Fairhope Board of Adjustments Agenda

November 17, 2025 – 5:00 PM

BOA 25.11 - 863 Creek Drive

BOA 25.15 - 20105 Bunker Loop

SITE PLAN
SCALE: 1" = 10'

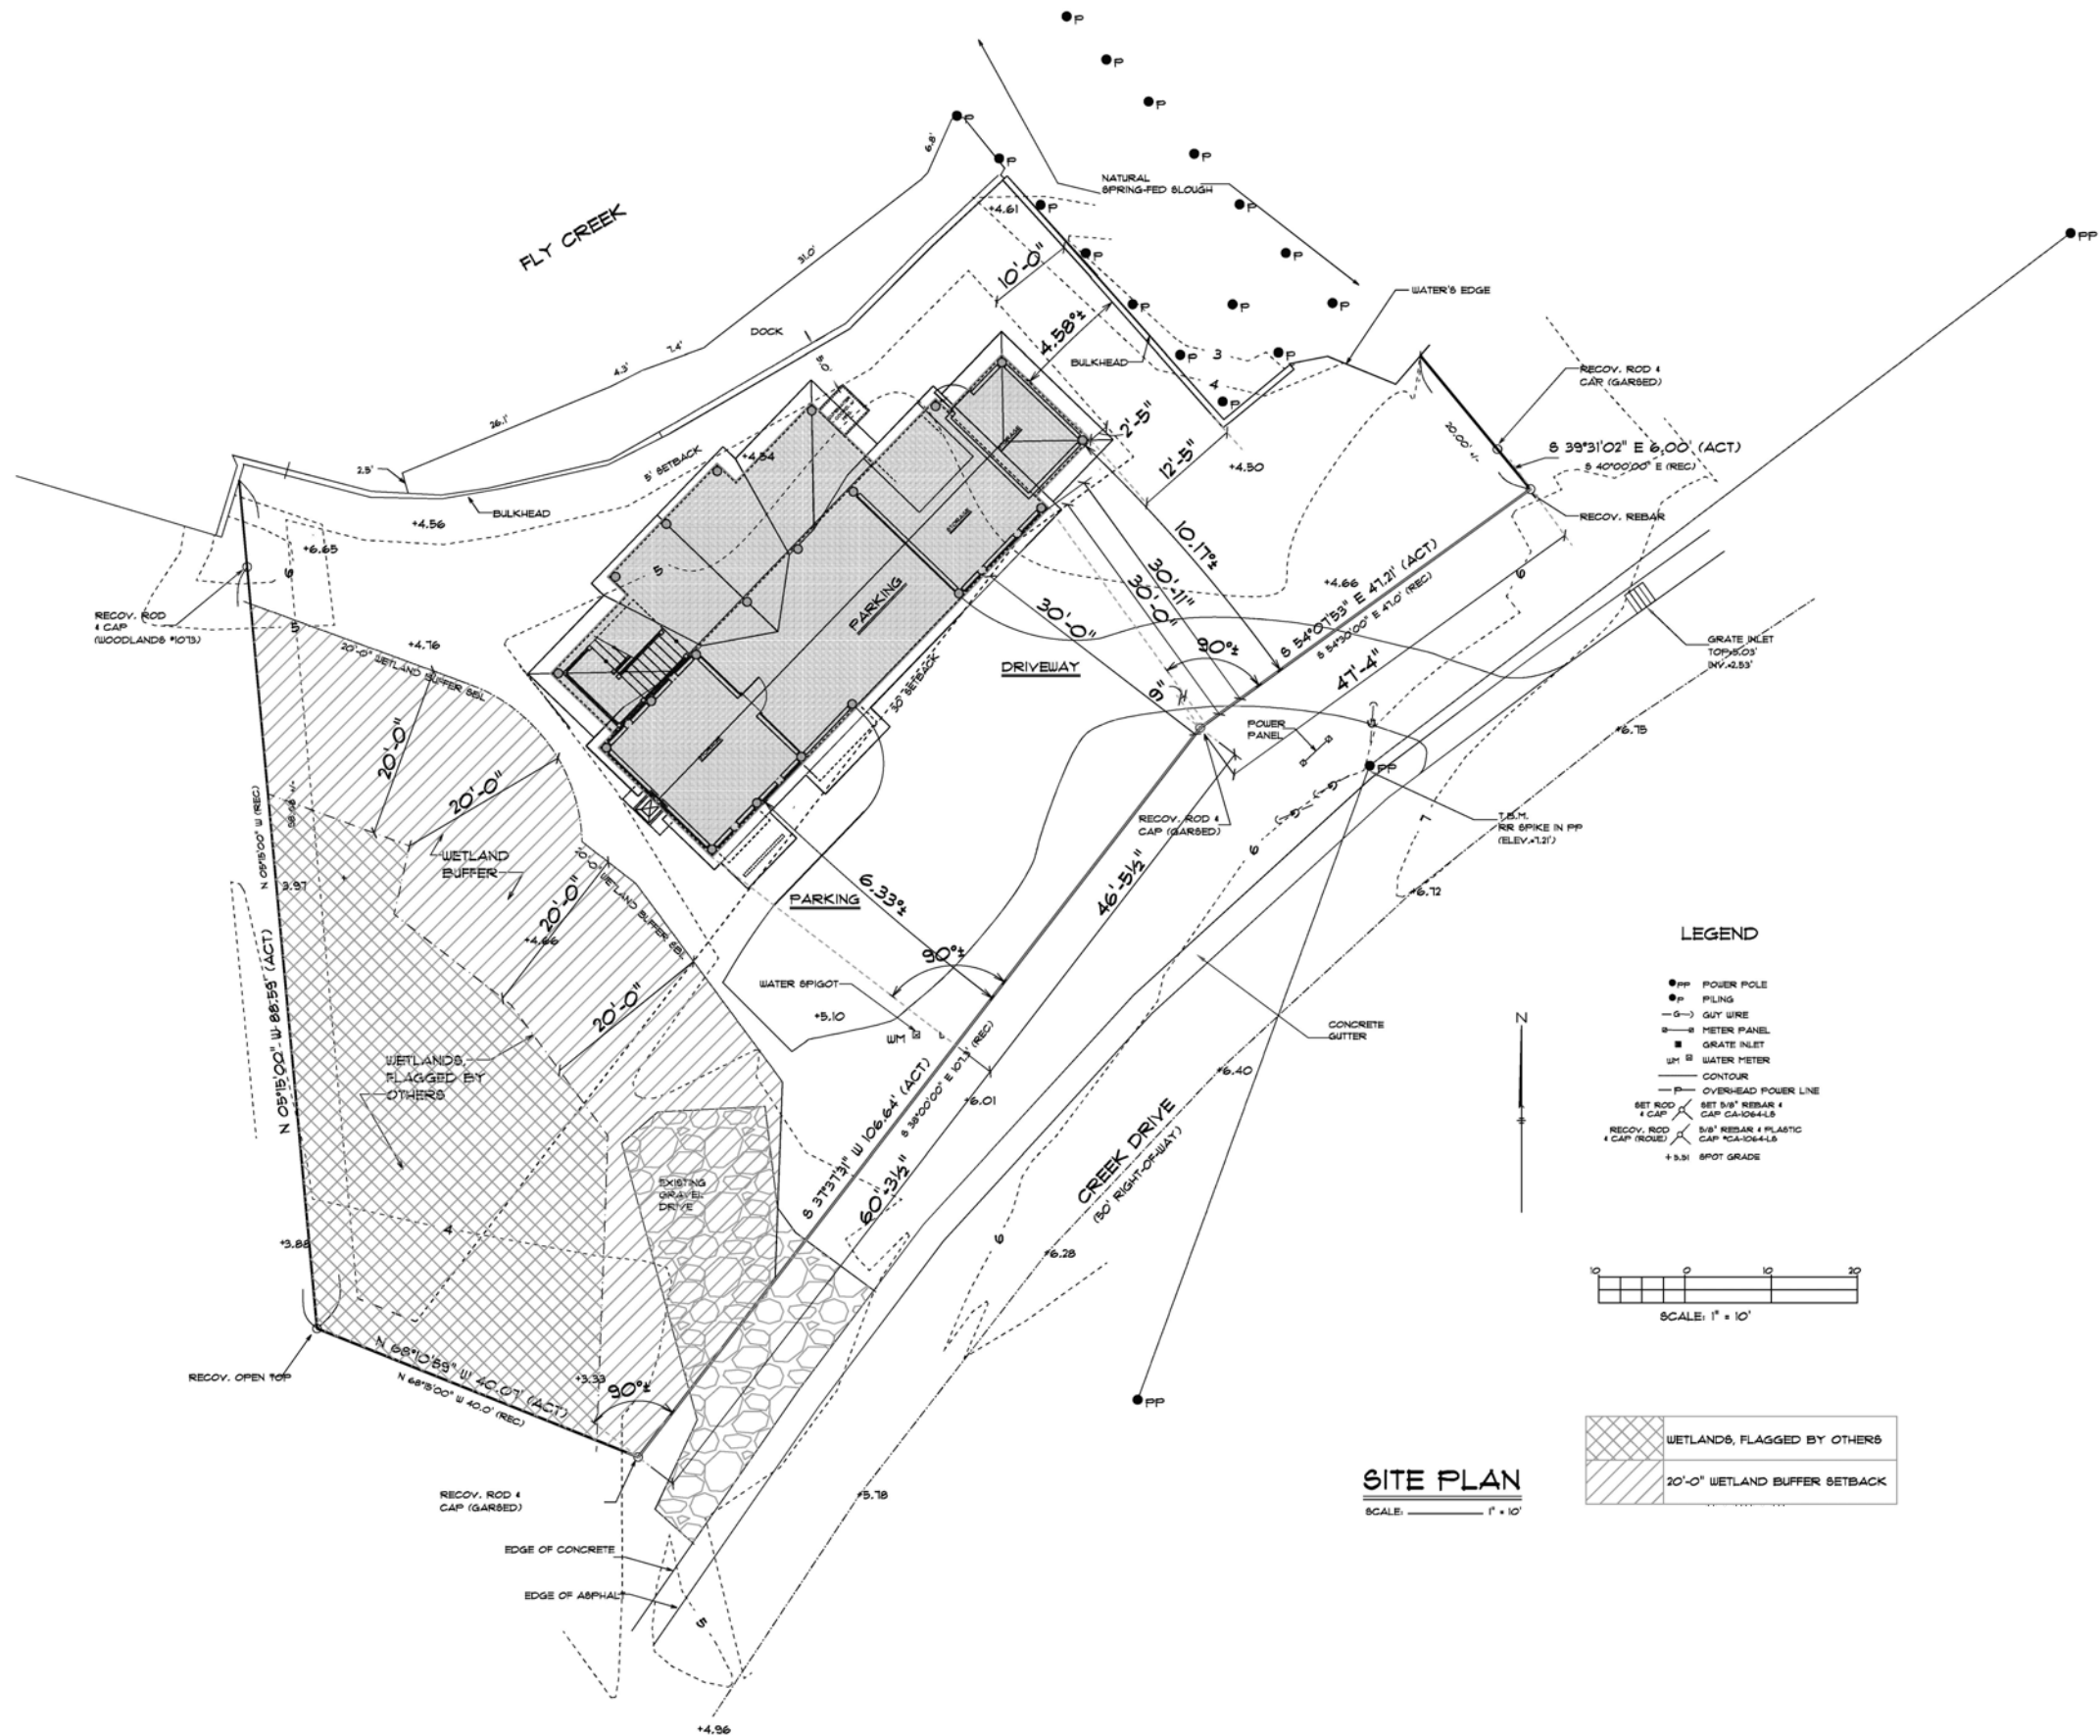
There is an existing gravel drive near the southwest corner of the property which is located inside the required wetland buffer zone. The Applicant stated in their 2022 Variance approval that their desire was to have a circular driveway to help accommodate storage of a recreational vehicle (RV) on site. At that time, this driveway was not illustrated on the site plan associated with the approved variance. However, when permit applications were later submitted the proposed plans illustrated a circular driveway cutting through the required wetland buffer, and as such, the permit was ultimately denied.

Under the current proposal, the house footprint has been enlarged from 1,213± square feet (2022 proposal) to 1,663± square feet resulting in the proposed home being located even closer to the wetland buffer. Additionally, the proposed site plan illustrates a driveway which, while not located inside the wetland buffer, is proposed to be within 1-foot 3-inches of the wetland buffer area. This is a serious concern of Staff’s as the proposed driveway could potentially be extended into the wetland buffer to connect to the existing gravel drive. As such, if approved, a condition requiring the removal of the existing gravel drive and replacing it with vegetation may be appropriate. This would remove any possibility of connecting the two drives and would have the added benefit of improving the wetland buffer area.

Based on the preceding, approval of the requested Variances seems to be reasonable and consistent with past approvals both for the subject site and surrounding properties. However, Staff is concerned about the possibility of the proposed impervious driveway extending into the required wetland buffer to connect with an existing gravel driveway. If approved, a condition requiring the removal of the existing gravel drive and replacing it with vegetation should be required. This would remove any possibility of connecting the two drives and would have the added benefit of improving the wetland buffer zone.

Figure 1: Encroachment of the Site Plan on the 2014 30' Front Setback

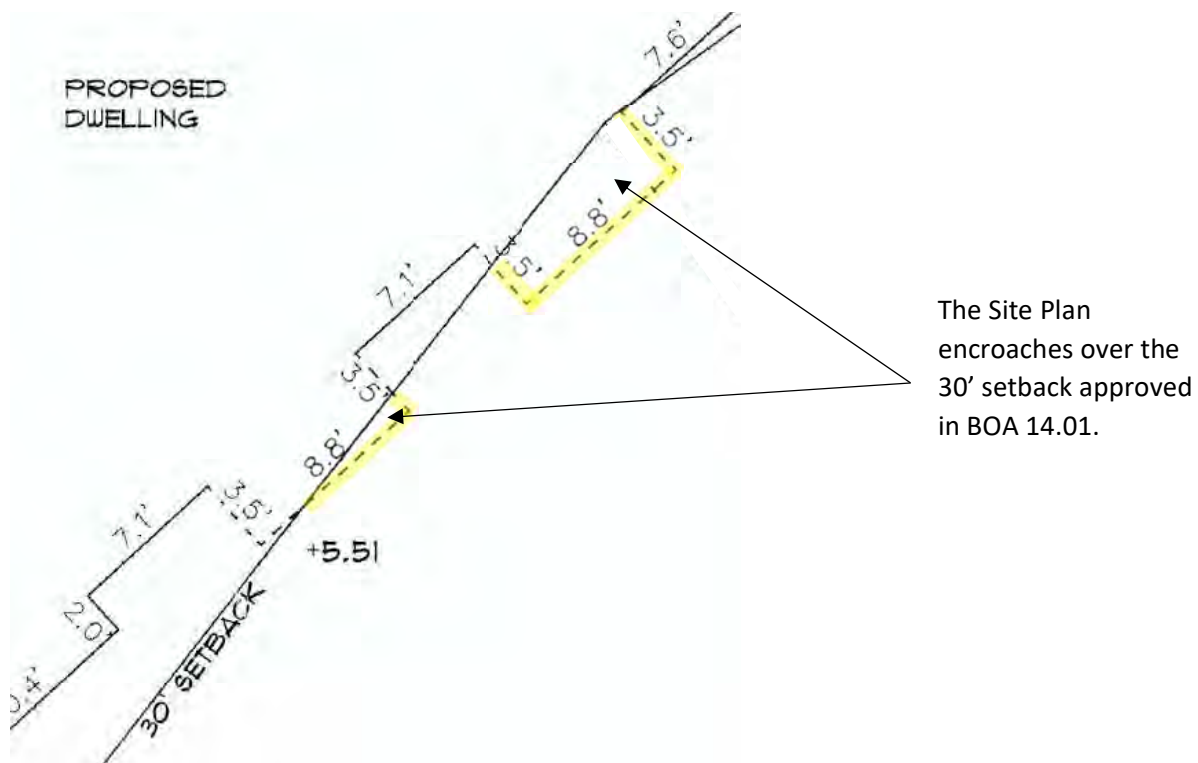
Current BOA Case 22.04 makes a similar request. The difference is the front setback variance request. Figure 1 details the proposed dwelling layout on the site in relation to the variances granted in BOA Case 14.01. The proposed site plan indicates that the dwelling is 26' from the front property line. As such, the applicant requests a 14' variance of the front setback, which is more than the 2014 BOA variance requested.

Figure 2: Site Topography

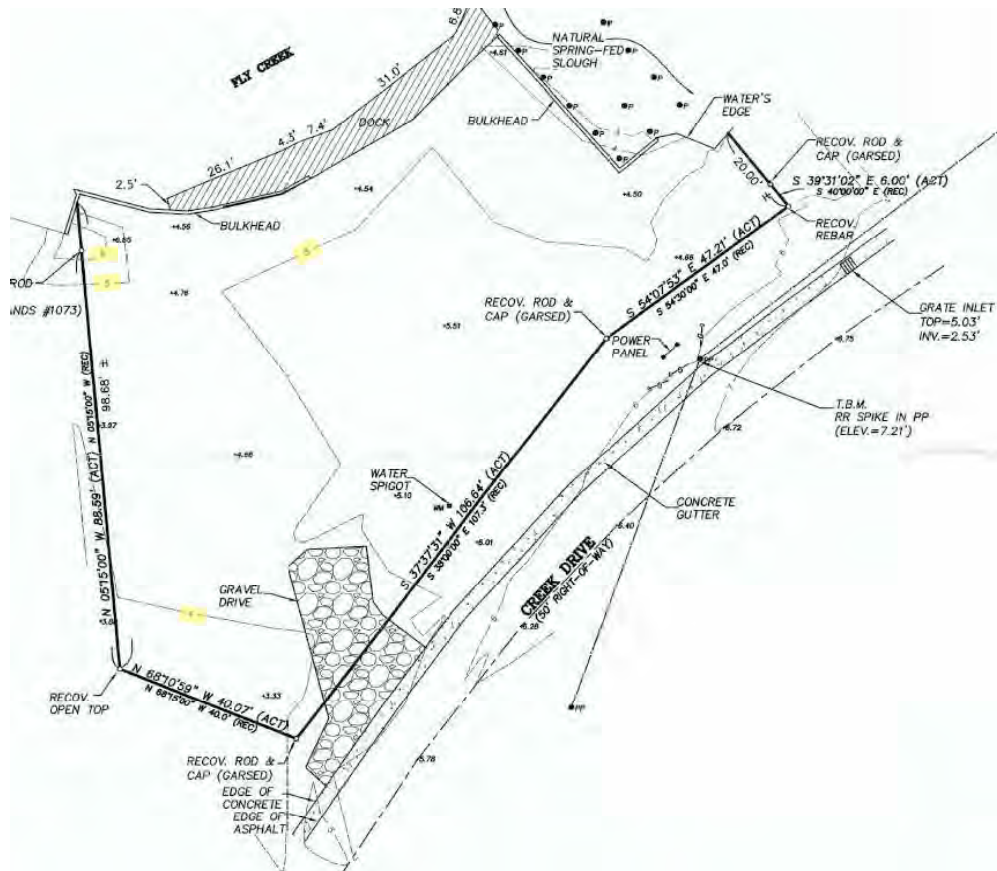
When discussing topography, however, there is no hardship. As shown in Figure 2, the site experiences three feet in total topography change over the entire site.

Figure 3: Adjusted Site Plan

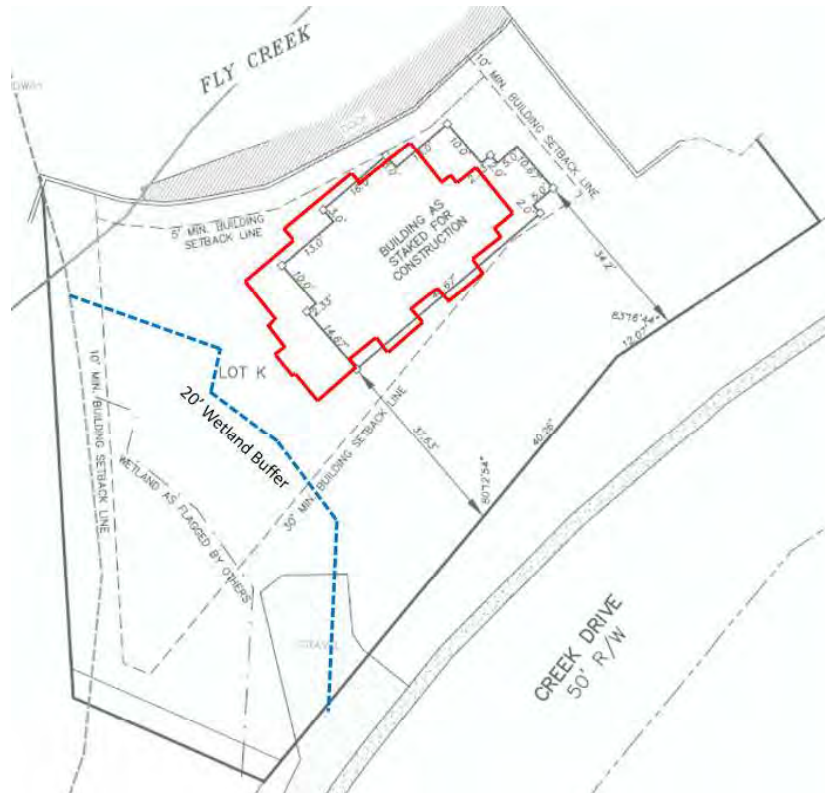
Since topography is not an issue, translation of any structure on site is possible. Figure 3 shows an adjusted site plan that translates the proposed dwelling within the setbacks as they were approved in 2014. The 20' wetland buffer is scaled in as well.
